RE: Lyons Quarry, Permit No. M-1977-208, Reclamation Cost Estimate
Adequacy Review Response No. 2

The following numbered items address the 10 adequacy items detailed in the February 16, 2024 DRMS Adequacy Review No. 2 of the Lyons Quarry Reclamation Cost Estimate.

Figure from Lyons Quarry Permit Technical Revision #2

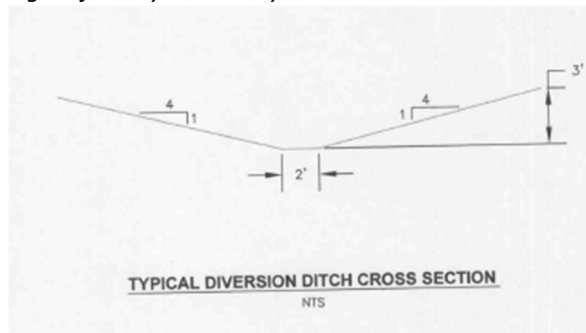
3. *What is the estimated volume of material to be removed for the stormwater diversion ditch?*

The diversion ditch around the disposal cell was estimated to be 4,000 linear feet. The original designs included in TR#2 show the design cross-section below. A 4,000-LF ditch with this cross section would result in approximately 6,222 CY of soil removal.

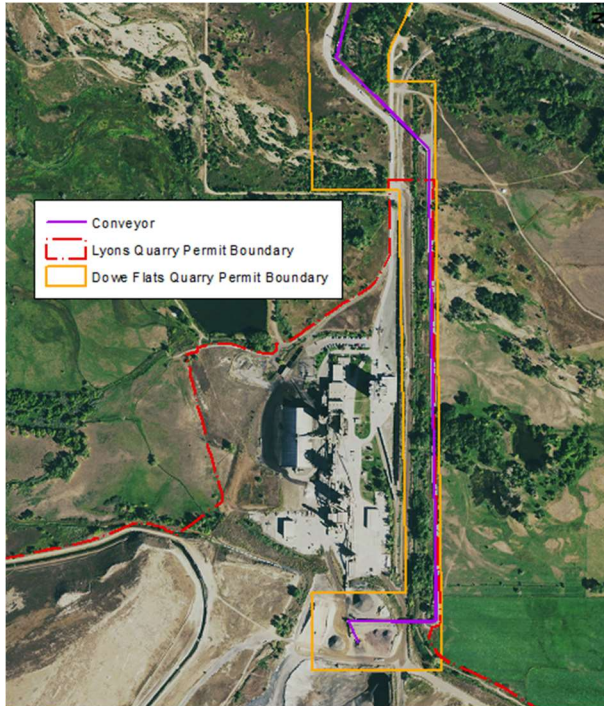
4. *There is a conveyor belt system located within the Lyons Quarry permit boundary that leads to the Dowe Flats permit. Please clarify if this system will be removed during the reclamation of Dowe Flats or the quarry permit. If the quarry permit please specify removal costs.*

As shown below, the Lyons Quarry permit (M-1977-208) boundary and the Dowe Flats Quarry permit (M-1993-041) boundary overlap where the conveyor that used to carry material from Dowe Flats to the Lyons Plant enters the Lyons Quarry permit boundary. The removal of the entire length of the conveyor and reclamation of the associated area is included in the bond for the Dowe Flats Quarry permit. The conveyor removal and reclamation are scheduled to be completed in 2024.
